1968 - 1970 Corvette: Service Bulletin: Depressed Park Windshield Wipers Unable to Park

Subject: Depressed Park Windshield Wipers Unable to Park

Bulletin No: 70-T-59

Date: May 5, 1971

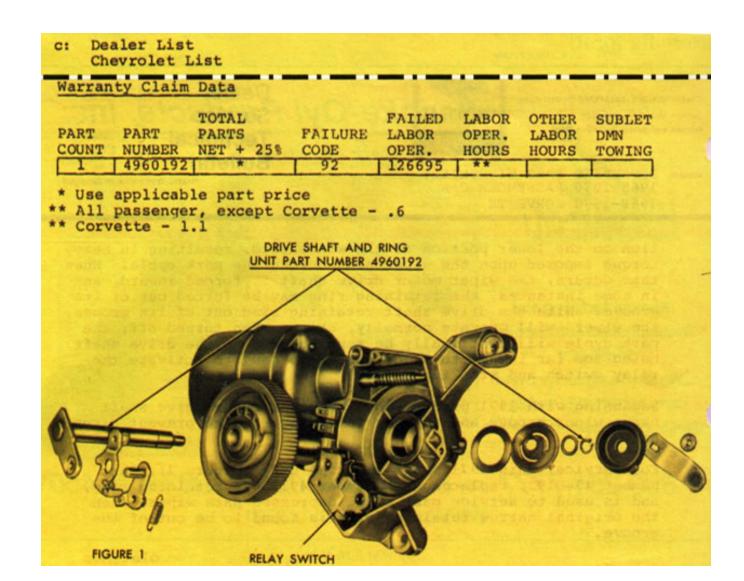
A few reports have been received on vehicles, equipped with depressed park windshield wipers, that the wipers do not park when turned off.

This problem usually is a result of heavy snow or ice accumulation on the lower portion of the windshield, resulting in heavy torque imposed upon the wiper arms during the park cycle. When this occurs, the wiper motor drive shaft is forced inward, and in some instances, the retaining ring may be forced out of its groove. With the drive shaft retaining ring out of its groove, the wipers will operate normally, except when turned off, the park cycle will continually be repeated due to the drive shaft being too far inward to allow the drive pawl to activate the relay switch and stop the motor.

Beginning with 1971 production, the wiper motor drive shaft has a wider groove and thicker retaining ring to prevent disengagement.

For service, this 1971 shaft and ring unit (Figure 1), Part Number 4960192, replaces Part Number 4911264, retaining ring, and is used to service past model depressed park wipers when the original narrow retaining ring is found to be out of the groove.
